UNITED STATES
NUCLEAR REGULATORY COMMISSION

SUBJECT: TELECON REGARDING NRC REGION IV INSPECTION FOR
TERMINATION OF HOLMES AND NARVER, INC.'S LICENSE
NO. SUA-1307

SUBJECT: PROCEDURE FOR RETIRING THE HOLMES & NARVER, INC.
 LICENSE NO. SUA-1307

SUBJECT: ENVIRONMENTAL REVIEW ON HOLMES & NARVER, INC.'S REQUEST
FOR SOURCE MATERIAL LICENSE COVERING THE RESEARCH &
DEVELOPMENT ACTIVITIES OF THE ABOVE FACILITY

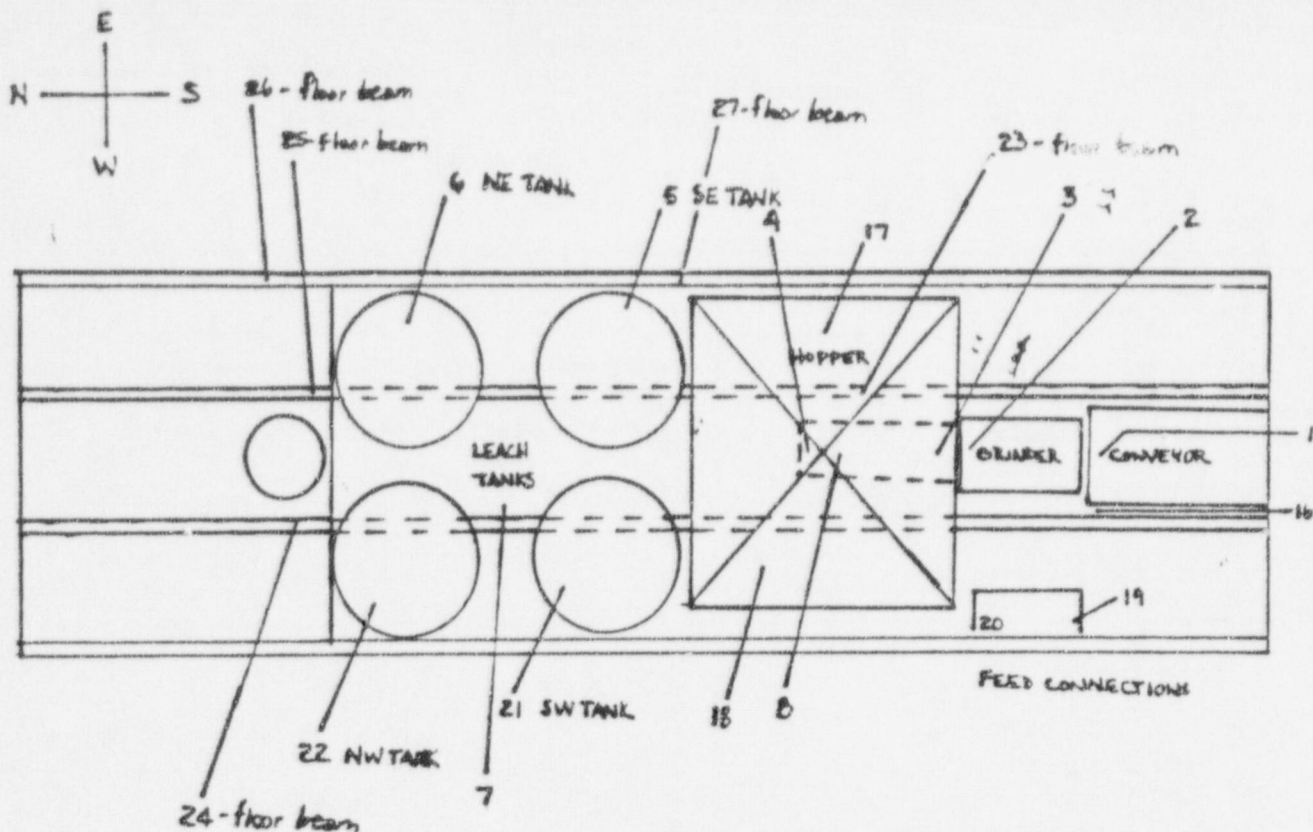
Mr. Spitzberg was able to confirm that survey locations included in your report dated September 15, 1982, were below the levels specified in the "Guidelines for Decontamination" for both fixed and removable alpha contamination. Additional surveys, however, indicated that five areas not included among your survey locations showed fixed contamination levels exceeding 5000 dpm/100cm² (see enclosed diagram). Therefore, these areas will require additional decontamination and surveys as may be necessary to reduce the levels below the limits of the Guideline. Please report all survey results in units of dpm/100cm².

Sample	dpm/100cm ²
23 trailer bed- floor beam	16200
24 " " " "	5175
25 " " " "	6900
26 " " " "	34500
27 " " " "	20700
